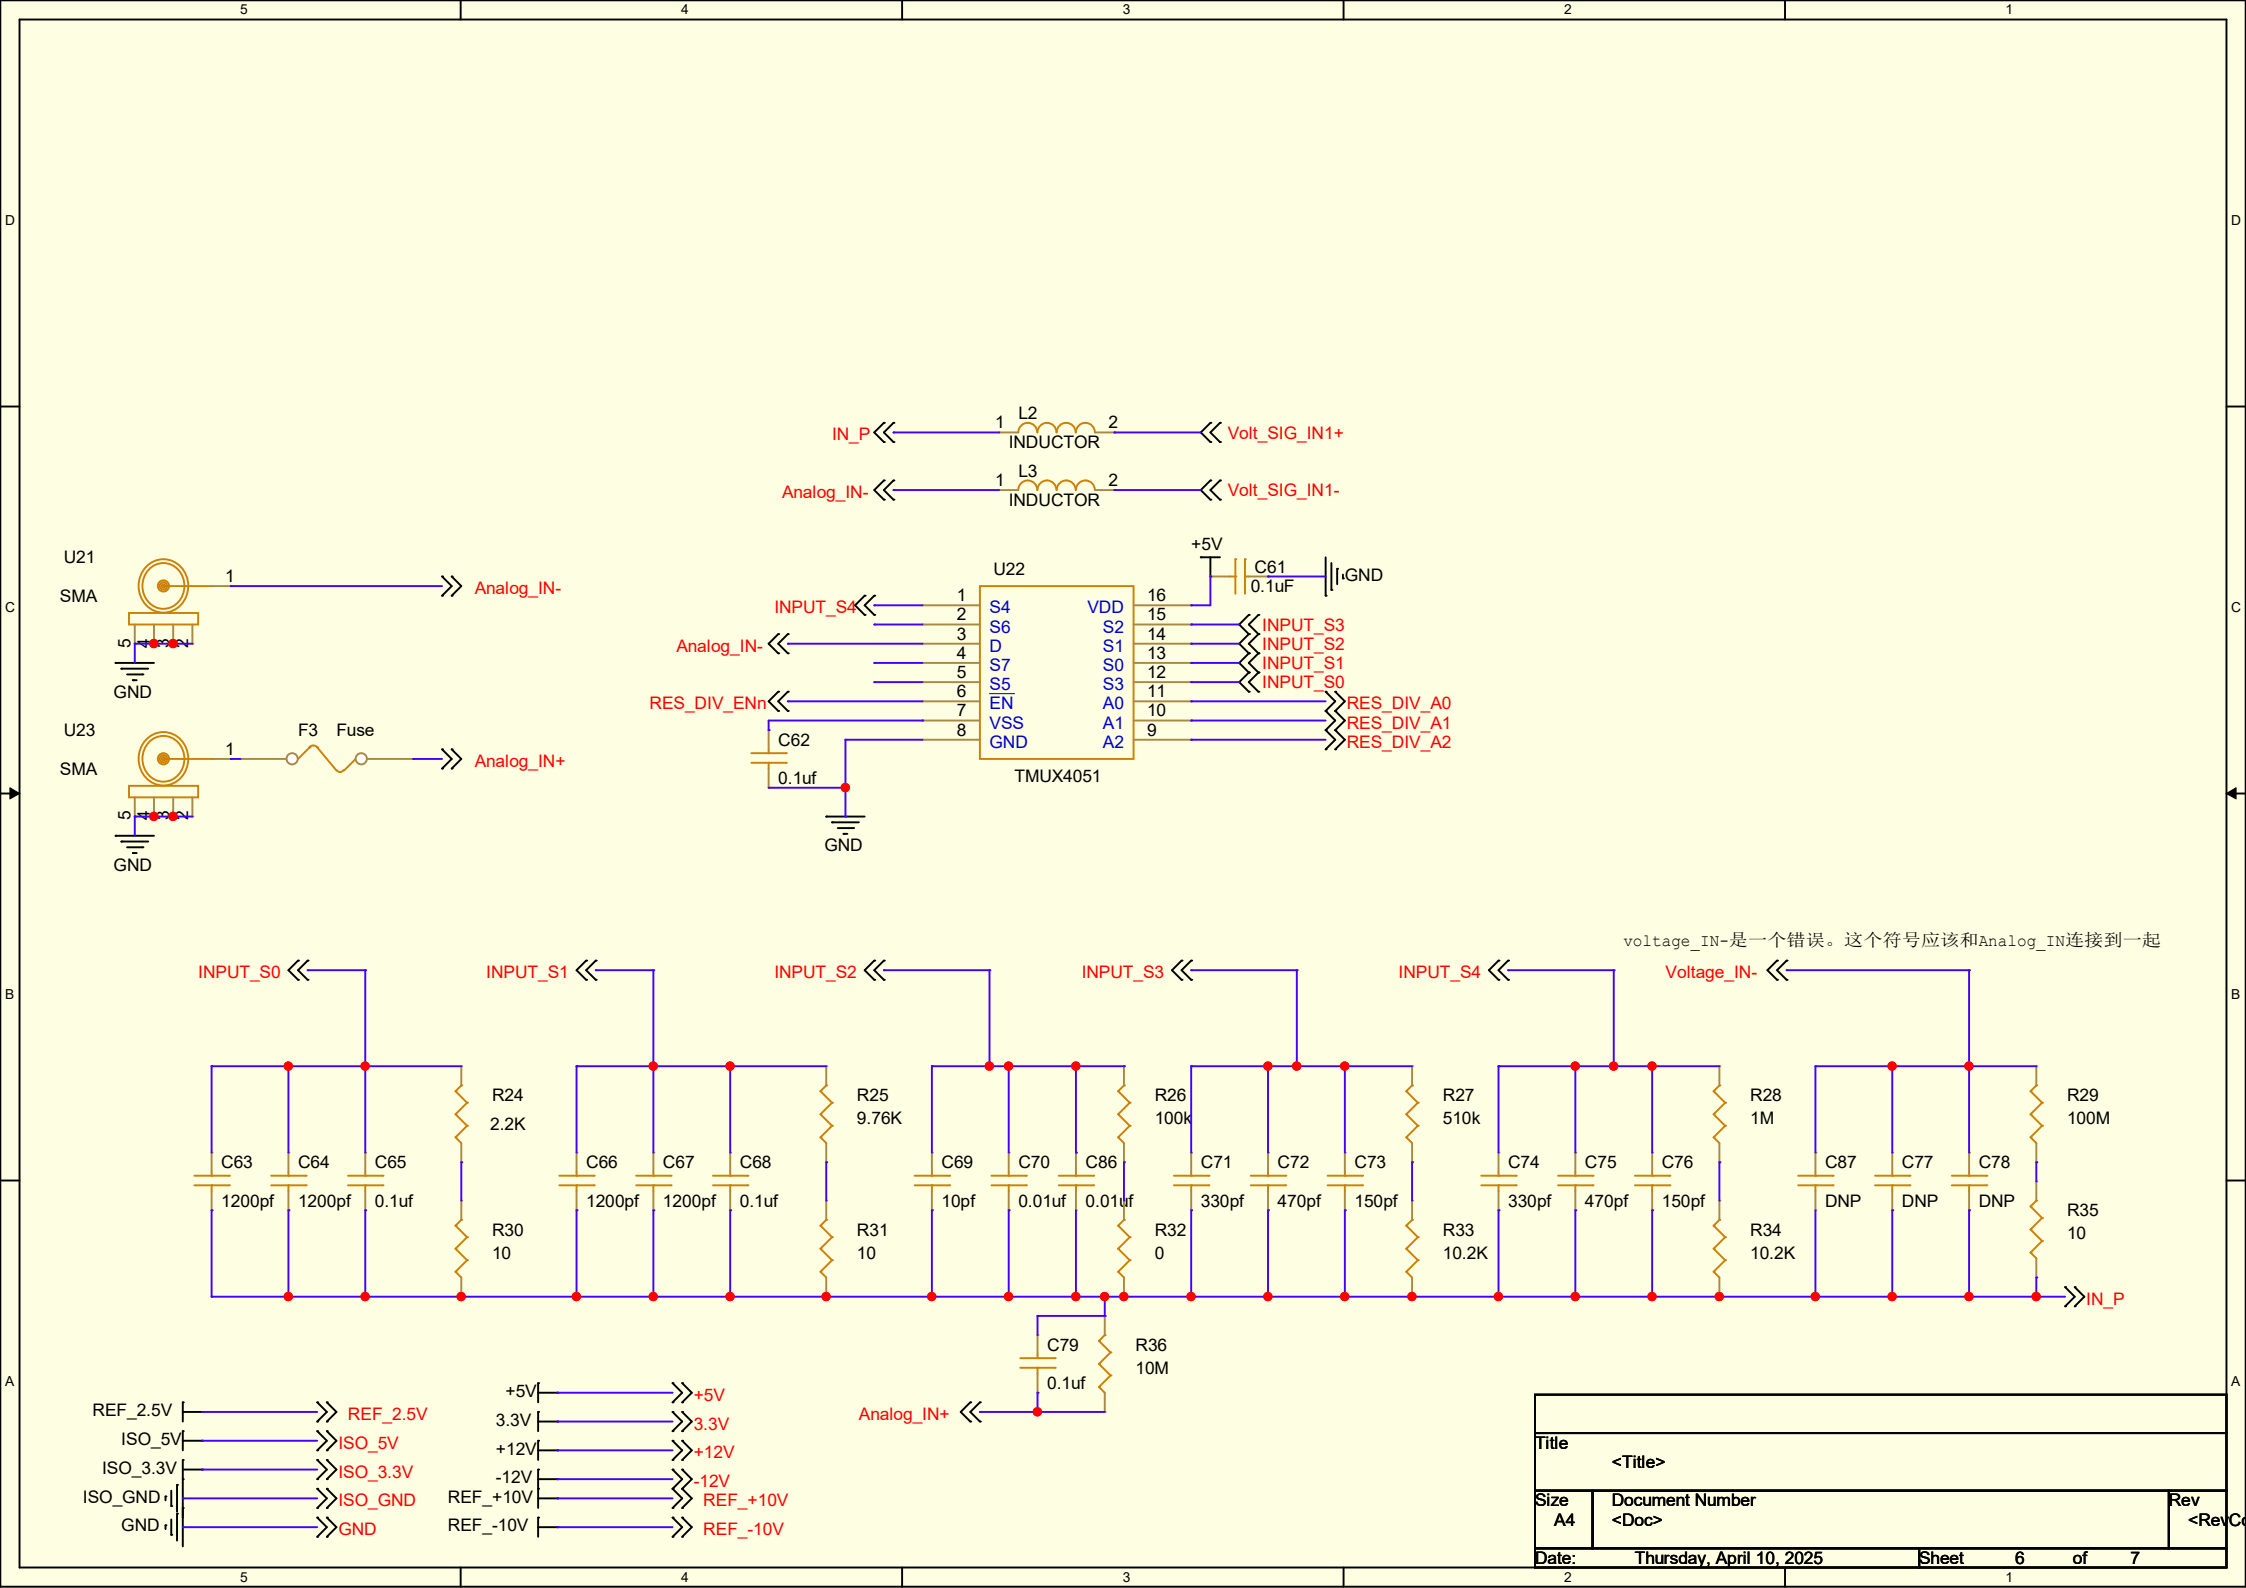
voltage_IN-是一个错误。这个符号应该和Analog_IN连接到一起
